ADDENDUM No. 1

Issued September 14, 2012

Commercial Marina and Ferry Way Improvements
12-1000
Beverly, Massachusetts

PROPOSED WORK PLAN

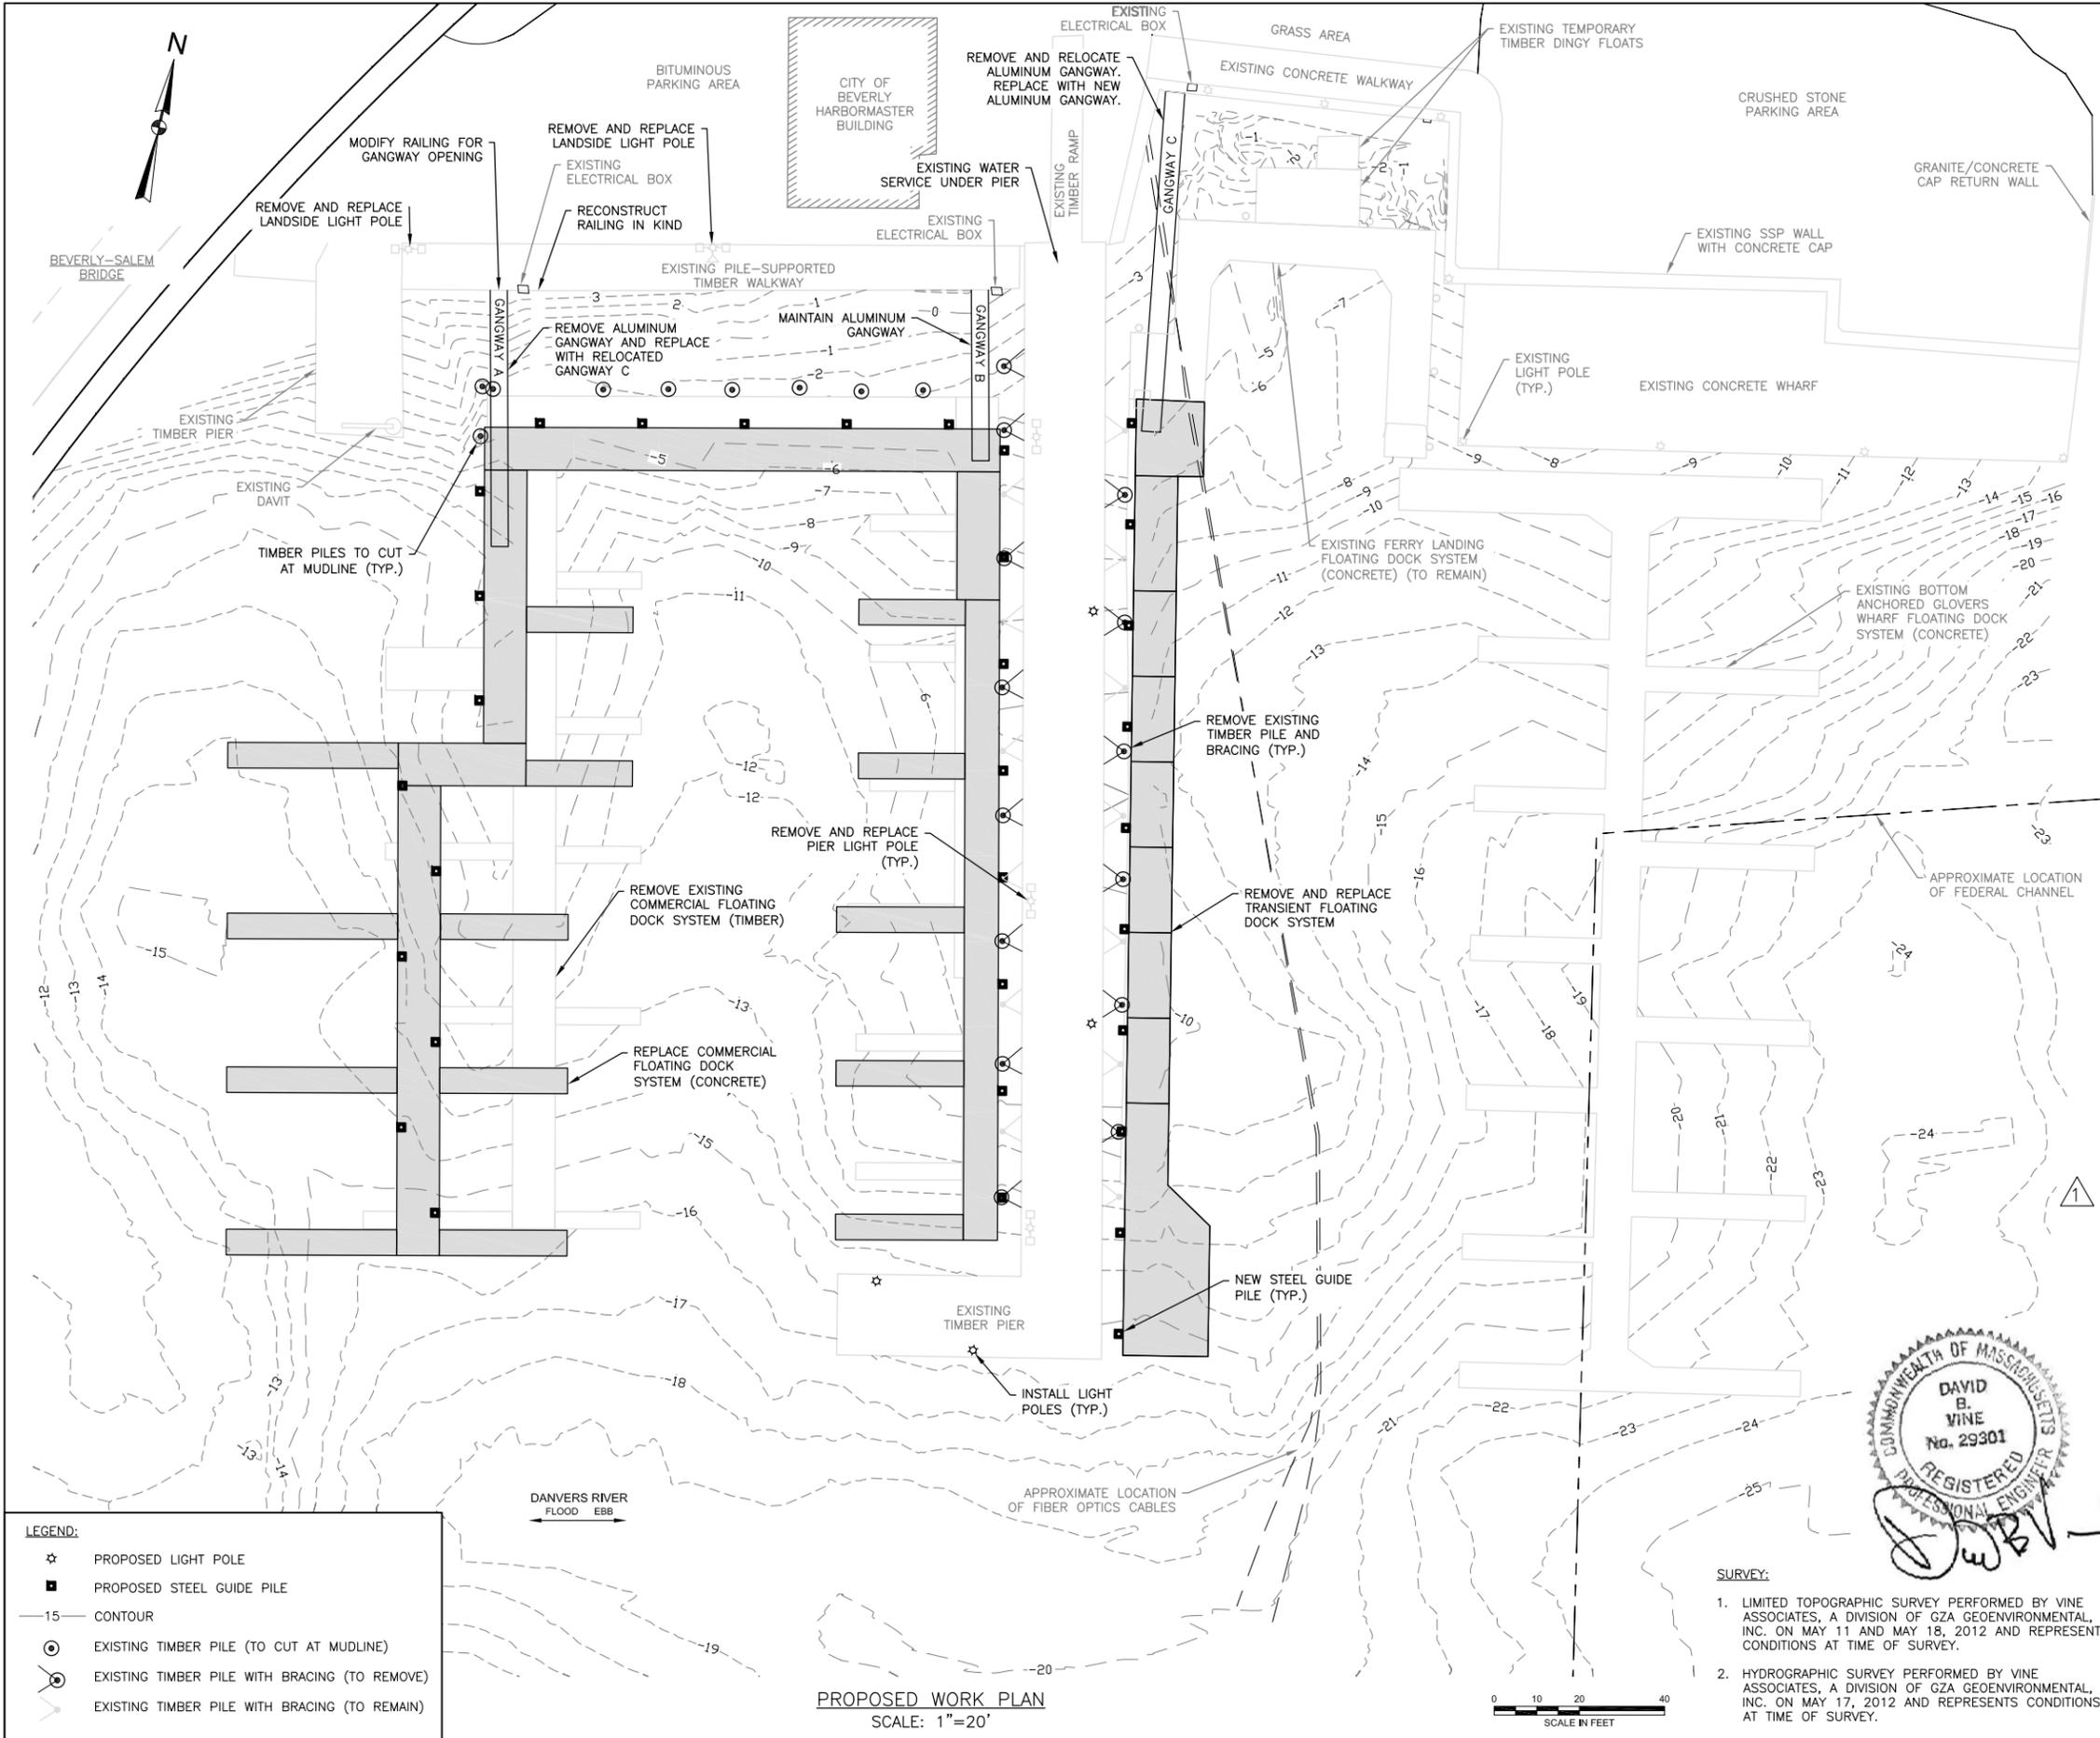
UL-1. 2.09 Water Service – Describes where the water is to be run and indicates “all materials shall meet the requirements of the City of Beverly Public Works Specifications”. Cannot find a description or drawing of the water system. Is it a design build left up to the dock manufacturer? Can we get a copy of the city specifications?

Answer: Water service for the floating dock system shall be 200 psi, 1” polyethylene pipe, per the City of Beverly. Connection shall be to the existing water service under the timber pier, as indicated on Sheet 3 of the Contract Drawings, titled Proposed Work Plan.

PROPOSED FLOAT AND CLEAT LAYOUT PLAN
SCALE: 1"=20'

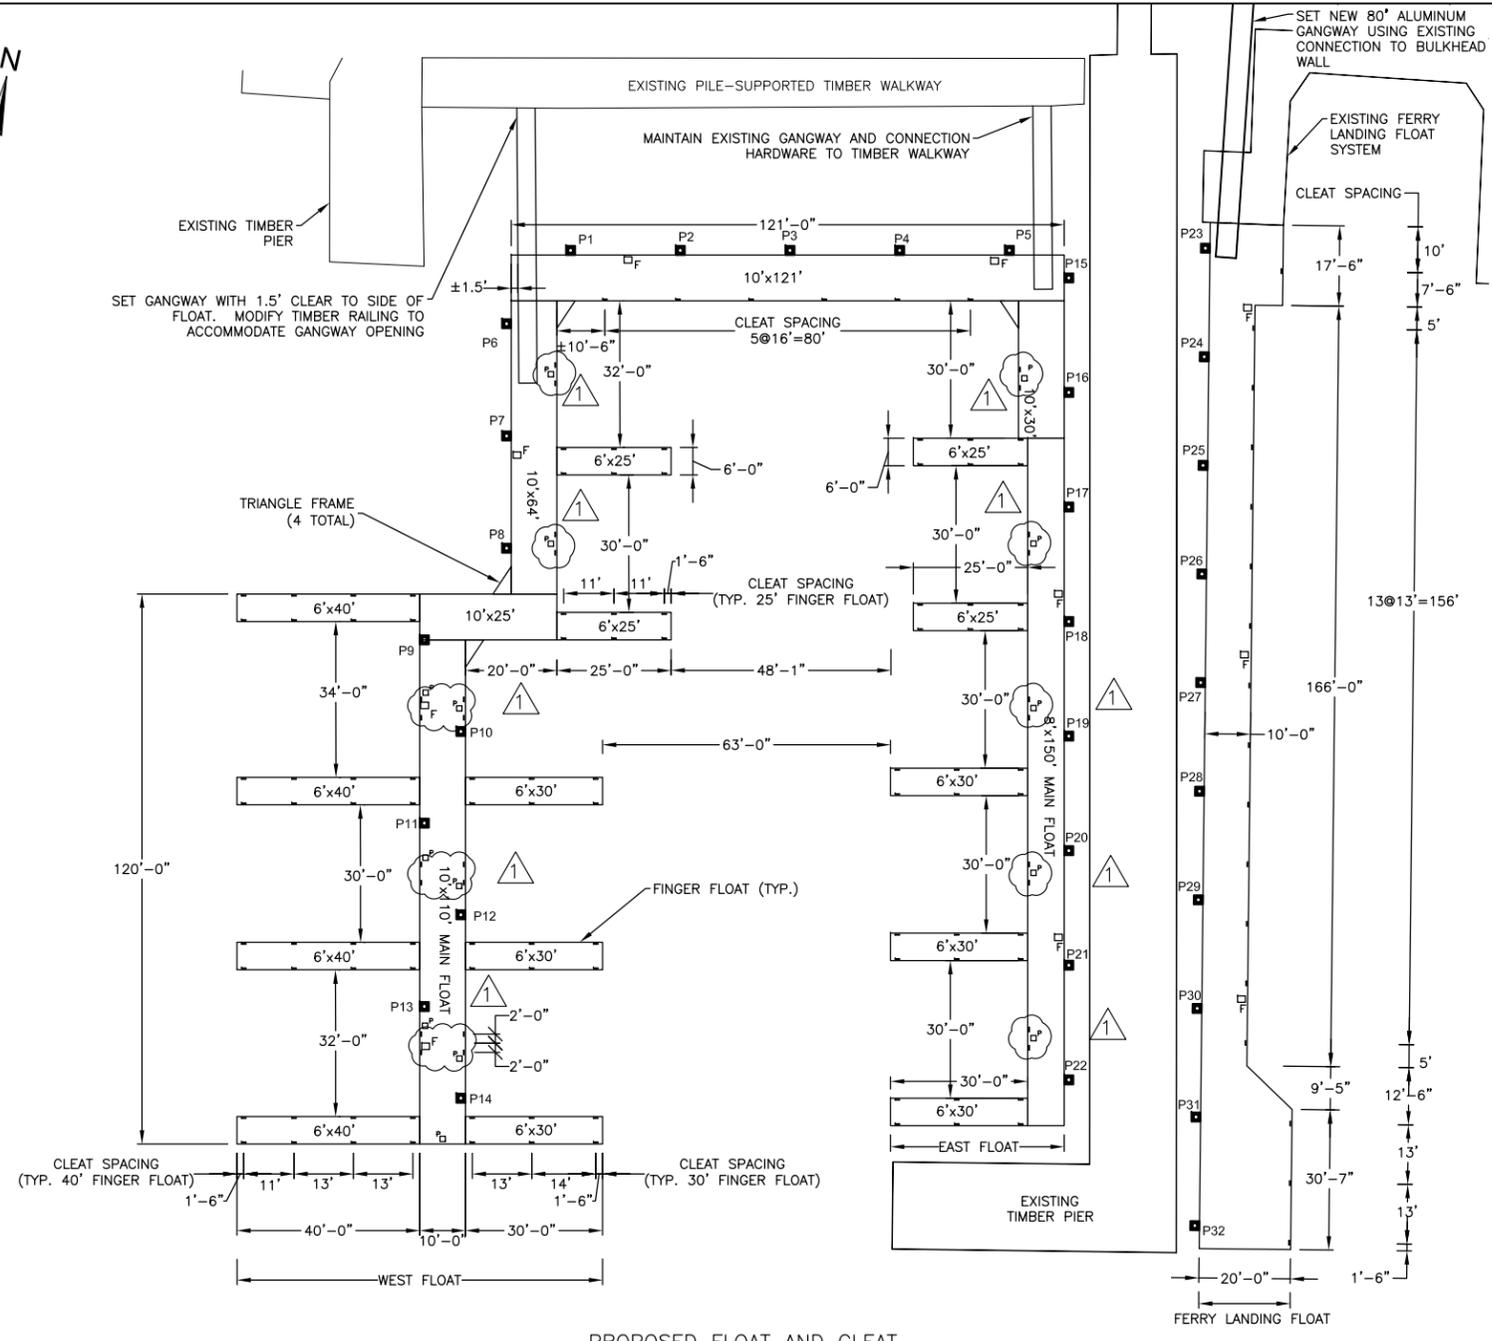
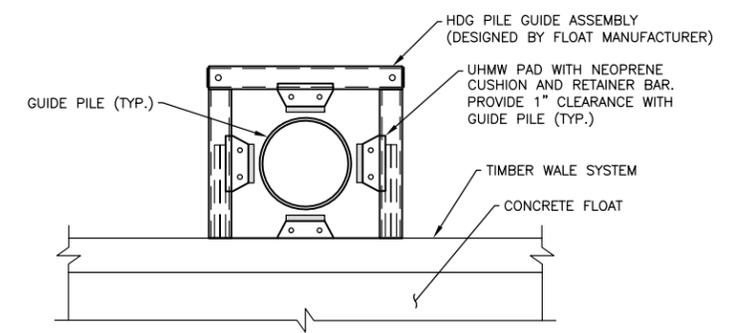
FP-1. Section C. #4 the description is cut off at the end. It stops at “,except at”.....

FP-8. Do you require any cleats on the walkways in the slips to tie stern lines?

Answer: Section 03303, Part 1.04, Section C.4 should read, “Finger floats shall have a flush mount connection to the main float. Triangular frame-type connections or connections between the finger float and main float that reduce the berth width or length are not permitted, except at the locations indicated on Sheet 9 of the Contract Drawings, titled Float and Cleat Layout Plan and Details.

Answer: Cleats shall be included along the main float between finger floats, with two cleats between each finger float as indicated on the attached revised Sheet 9 of the Contract Drawings, titled Float and Cleat Layout Plan and Details.

ELECTRICAL LIGHT, POWER & LIGHTING PLAN, FIXTURE SCHEDULE & DETAIL

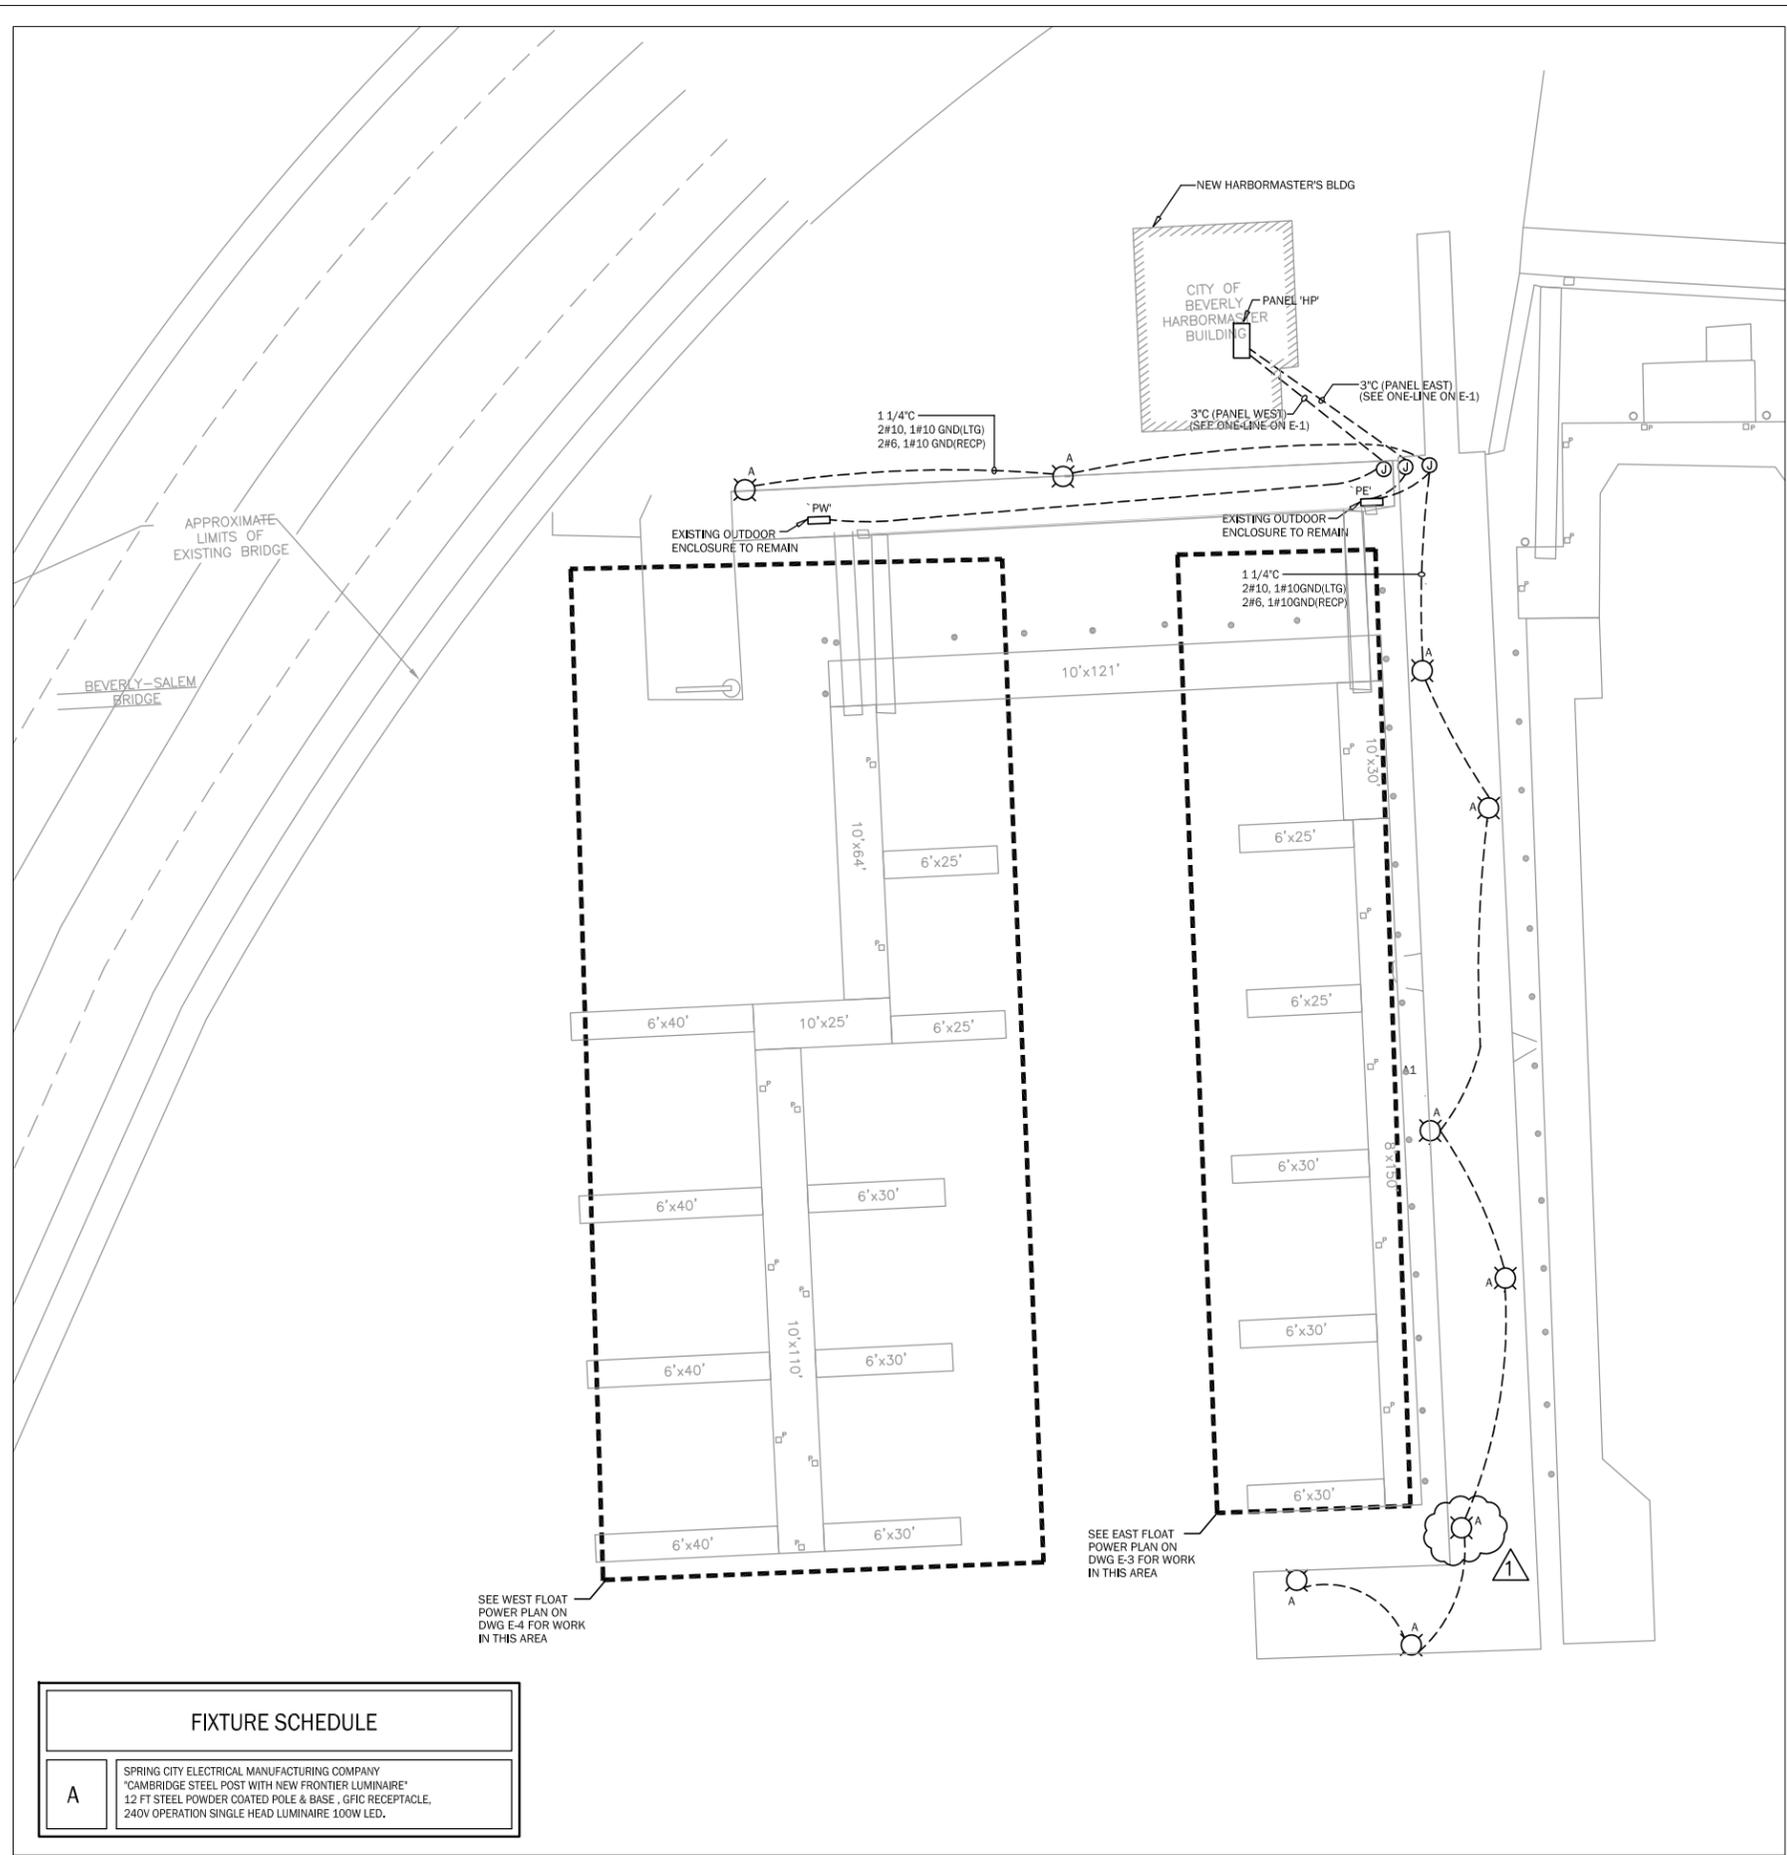
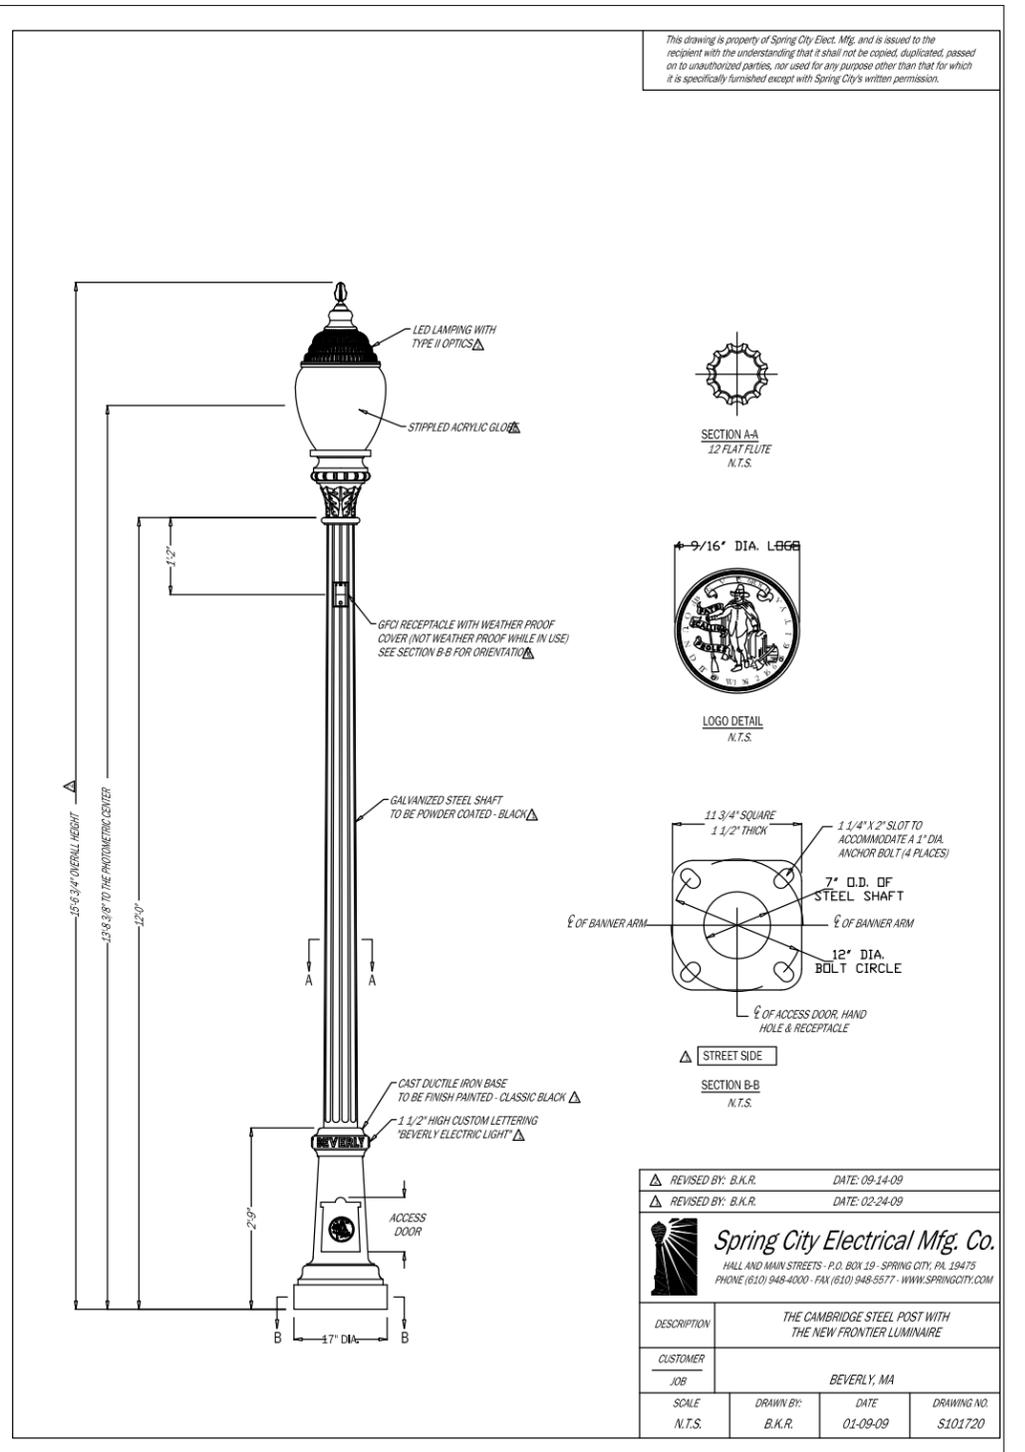
UL-2. There are 9 fixtures on the sight lighting schematic but 8 on the lighting power plan. Are there supposed to be 8 or 9 fixtures?

UL-5. The drawing on page E-2 shows 8 pole lights and the one-line diagram on page E-1 has 9 shown. What is the correct number of new fixtures?

UL-6. The drawing E-1 has one of the double shoe box style fixtures shown in a new location. Is the intent to relocate one of the existing lighting poles?

UL-8. On drawings E-2, on the lower end of the walkway where the new light poles are going, there is a double head fixture shown but not connected to the new circuitry. On drawing E-1, it shows 7 new single luminaire poles. Please clarify if this fixture is to be a new single head luminaire or if it is a new double head, or if it is existing.

Answer: There are 9 total light fixtures. See Re-Issued Electrical Drawings attached with this Addendum.

Answer: All light poles shall be new single luminaire poles. See Answer for question UL-2.

Answer: There are 9 total new light poles. All light poles shall be single luminaire poles. See Answer for question UL-2.
